S E R V I C E N O T E

8657J Pi/4 DQPSK Signal Generator

Reversed Capacitor On A6 Assembly

Fig. 1: Partial view of A6 board 08657-60171 and A6C417

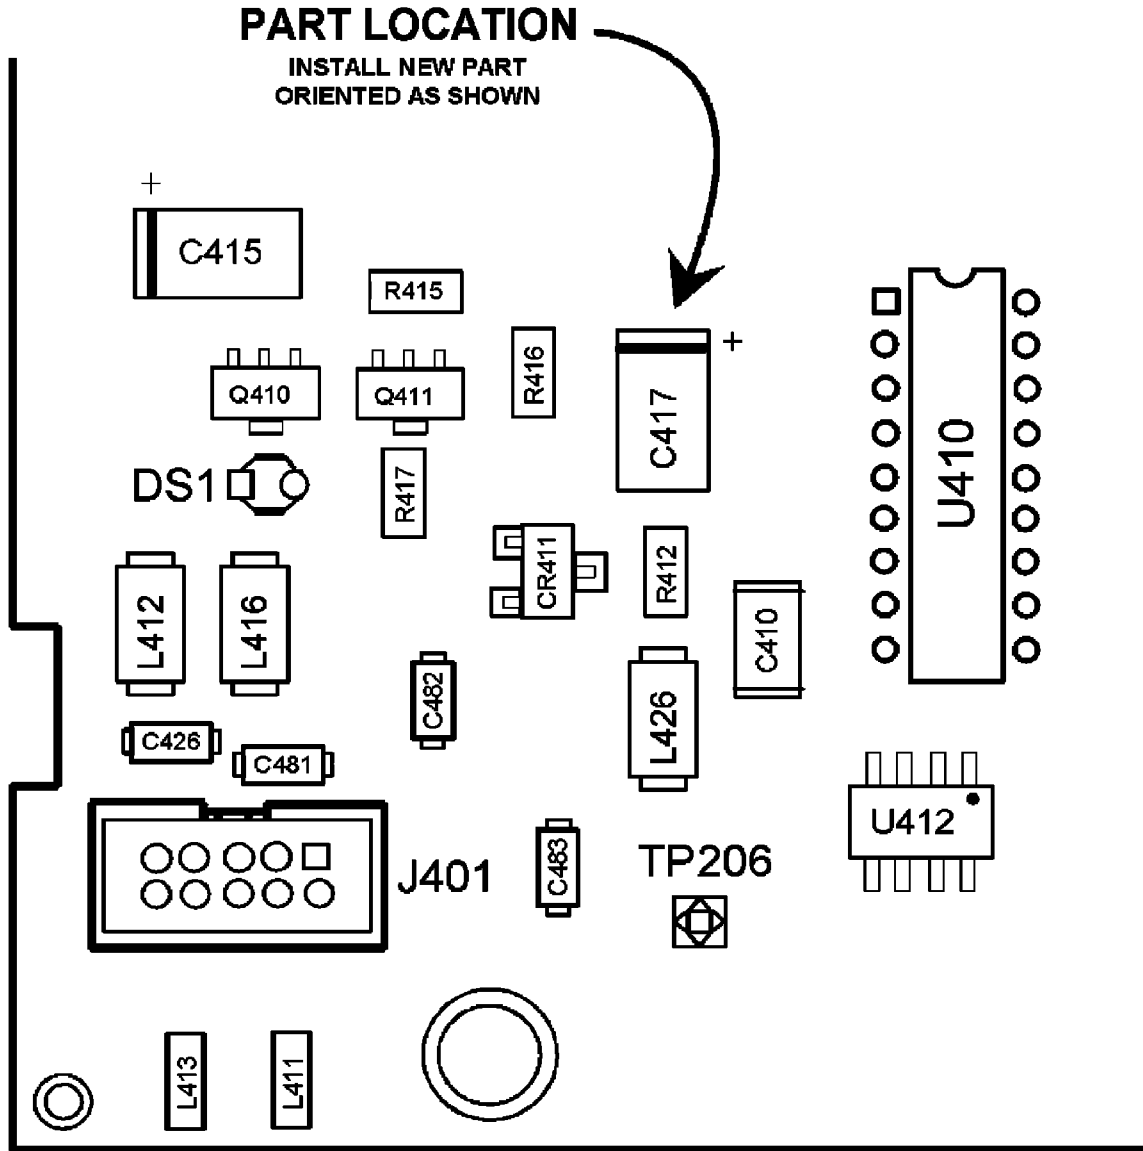
8657Js (with serial number noted above) have capacitor A6C417 installed backwards on the A6 Output Assembly (08657-60976). The polarity marking silkscreened on the PC board is incorrect and should be ignored when installing the replacement component.

Locate and replace A6C417 with part number noted above. Refer to Figure 1 for correct location and orientation of C417. This component is an SMT (Surface Mount Technology) component which requires appropriate tools and techniques.

NOTE: DO NOT USE THE POLARITY MARKING ON THE PC BOARD TO ORIENT THE REPLACEMENT COMPONENT. DO NOT RE-USE THE ORIGINAL COMPONENT.
